UNITED STATES PATENT AND TRADEMARK OFFICE

Office Action Summary

10/646,478

DETAILED ACTION

FIG. 6

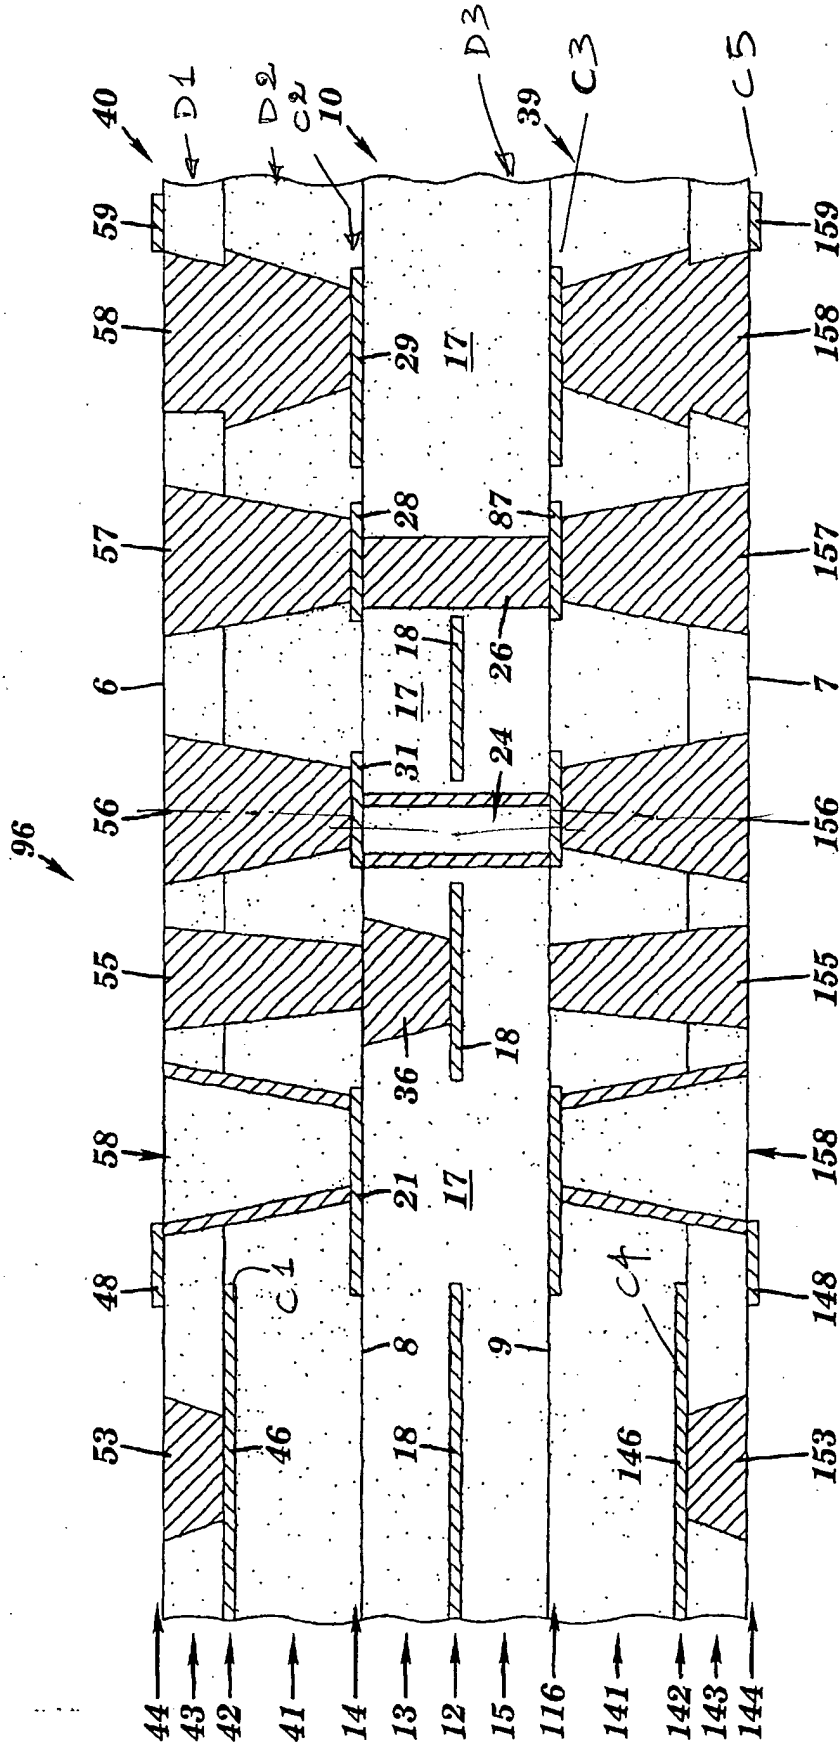
Regarding claim 40, Carpenter, in figure 6, discloses a substrate comprising: a first dielectric layer (D1, as marked up on figure 6 in appendix "A"); a second dielectric layer (D2, as marked up on figure 6 in appendix "A"); a first conductive layer (C1, as marked up on figure 6 in appendix "A"); between the first and second dielectric layers; a third dielectric layer (D3, as marked up on figure 6 in appendix "A"); the second dielectric layer being between the first and third dielectric layers; a second conductive layer (C2, as marked up on figure 6 in appendix "A"); between the second dielectric layer and the third dielectric layer, the second conductive layer including a first skip via (57) that extends through the first and second dielectric layers; and a third conductive layer (C3) on the third dielectric layer, the third conductive layer including a second via (26) that extends through the third dielectric layer, the second via and the first skip via being stacked on top of one another (see marked up figure 6 in appendix "A").

Regarding claim 41, Carpenter further discloses the first skip via includes a longitudinal axis (longitudinal axis passing through the first skip via, see marked up in figure 6, in appendix "A") and the second via includes a longitudinal axis (longitudinal axis passing through the second via, see marked up in figure 6, in appendix "A"), the longitudinal axis of the first skip via being substantially aligned with the longitudinal axis of the second via (see marked up in figure 6, in appendix "A").

Regarding claim 42, Carpenter further discloses the first, second and third dielectric layers are formed on a core (C5, see marked up in figure 6, in appendix "A").

Regarding claim 43, Carpenter further discloses a fourth conductive layer (C4, see marked up in figure 6, in appendix "A") between the first dielectric layer and the core.

Regarding claim 44, Carpenter further discloses the first, second and third conductive layers are patterned conductive layers (see figure 6).

The applicant argues that layer C2 (second conductive layer) does not include any vias. Therefore, Carpenter does not teach or suggest "the second conductive layer including a first skip via that extends through the first and second dielectric layers". This is not found to be correct. Via (57) as shown in marked up figure 6 (appendix "A"), does extend through dielectric layer D1 and D2 and is connected with the conductive layer (C2).

Applicant further argues that layer C3 (third conductive layer in marked up figure 6 (appendix "A")) does not include any via. Therefore, carpenter does not teach or suggest "the third conductive layer including a second via that extends through the third dielectric layer". This is not found to correct. Via (26) as shown in marked up figure 6 (appendix "A"), does extend through the dielectric layer D3 and is connected with the conductive layer (C3).

FIG. 7

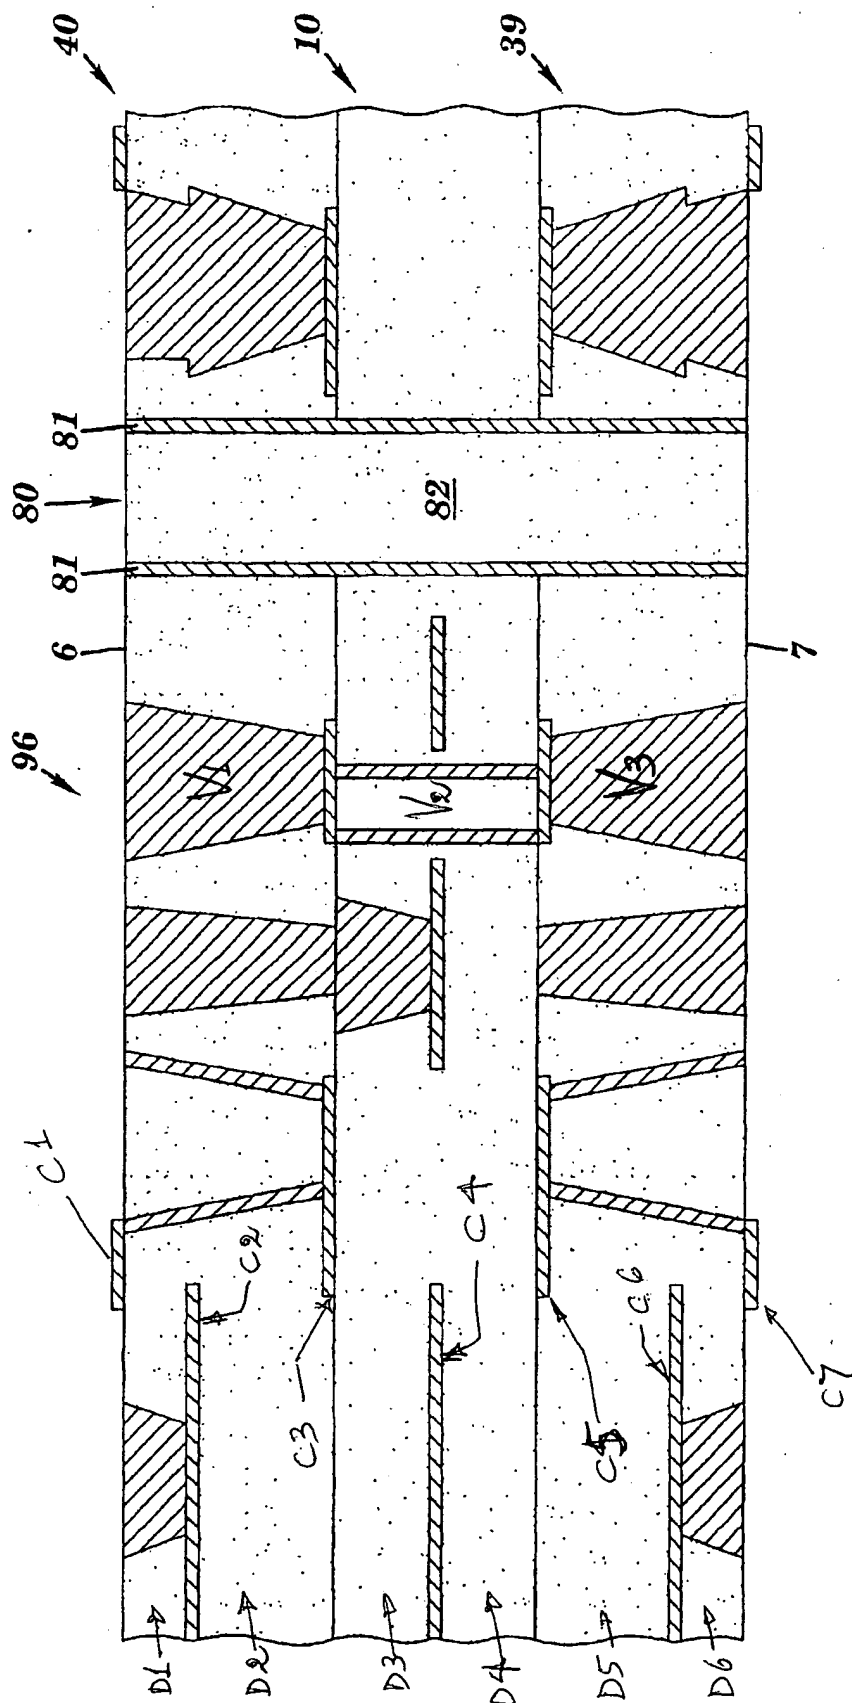
Regarding claim 47, Carpenter, in figure 7, discloses a substrate comprising: a first dielectric layer (D1, marked up on figure 7 in appendix "B"); a second dielectric layer (D2, marked up on figure 7 in appendix "B"); a first conductive layer (C2, marked up on figure 7 in appendix "B") between the first and second dielectric layers; a third dielectric layer (D3, marked up on figure 7 in appendix "B"), the second dielectric layer being between the first and third dielectric layers; a second conductive layer (C3, marked up on figure 7 in appendix "B") between the second and third dielectric layers, the second conductive layer including a first skip via (V1, marked up on figure 7 in appendix "B") that extends through the first and second dielectric layers; a fourth dielectric layer (D4, marked up on figure 7 in appendix "B"), the third dielectric layer being between the second and fourth dielectric layers; a third conductive layer (C4, marked up on figure 7 in appendix "B") between the third and fourth dielectric layers; and a fourth conductive layer (C5, marked up on figure 7 in appendix "B") on the fourth dielectric layer, the fourth conductive layer including a second skip via (V2, marked up on figure 7 in appendix "B") that extends through the third and fourth dielectric layers, the second skip via and the first skip via being stacked on top of one another (see marked figure 7 in appendix "B").

Regarding claim 48, Carpenter further discloses the first skip via and the second skip via each include a longitudinal axis (longitudinal axis of axis of first skip via and second skip via), the longitudinal axis of the first skip via being substantially aligned

with the longitudinal axis of the second skip via (see marked up figure 7 in appendix "B").

Regarding claim 49, Carpenter further discloses the first, second, third and fourth dielectric layers are formed on a core (C7, as marked up on figure 7 in appendix "B").

Regarding claim 50, Carpenter further discloses a fifth conductive layer (C6, marked up on figure 7 in appendix "B") between the first dielectric layer and the core.

Regarding claim 51, Carpenter further discloses the first, second, third and fourth conductive layers are patterned conductive layers (see figure 7).

Regarding claim 54, Carpenter discloses all the features of the claimed invention as applied to claim 47 above, including a fifth dielectric layer (D5, marked up on figure 7 in appendix "B"), the fourth conductive layer (C5, marked on figure 7 in appendix "B") being between the fourth and fifth dielectric layers; a sixth dielectric layer (D6, marked up on figure 7 in appendix "B"), the fifth dielectric layer being between the fourth and sixth dielectric layers; a fifth conductive layer (C6, marked up on figure 7 in appendix "B") between the fifth and sixth dielectric layers; a sixth conductive layer (C7, marked up on figure 7 in appendix "B") on the sixth dielectric layer. Carpenter further discloses a third sip via (V3, marked up on figure 7 in appendix "B"), a third skip via that extends through the fifth and sixth dielectric layers, but does not disclose the sixth conductive layer including connected to the third skip via. However, as can be seen at various places in the figure, the conductor layer / patterns are connected to the via depending upon the desired electrical connection for signal, power or ground connections.

substantially aligned with the longitudinal axis of the second and third skip vias (see marked up figure 7 in appendix "B").

Regarding claim 56, Carpenter further discloses the first, second, third, fourth, fifth and sixth conductive layers are patterned conductive layers (see figure marked up figure 7 in appendix "B").

Similarly regarding the independent claim 47, the applicant argues that Carpenter does not disclose or teach the second conductive layer including a first skip via that extends through the first and second dielectric layers and the fourth conductive layer including a second skip via that extends through the third and fourth dielectric layers. This is not found to be correct. Via (V1, as shown in figure 7, appendix B) extend through dielectric layers D1 and D2 and is connected to conductive layer C3. Similarly Via (V2) extend through dielectric layer D3 and D4 and connected to conductive layer C5.
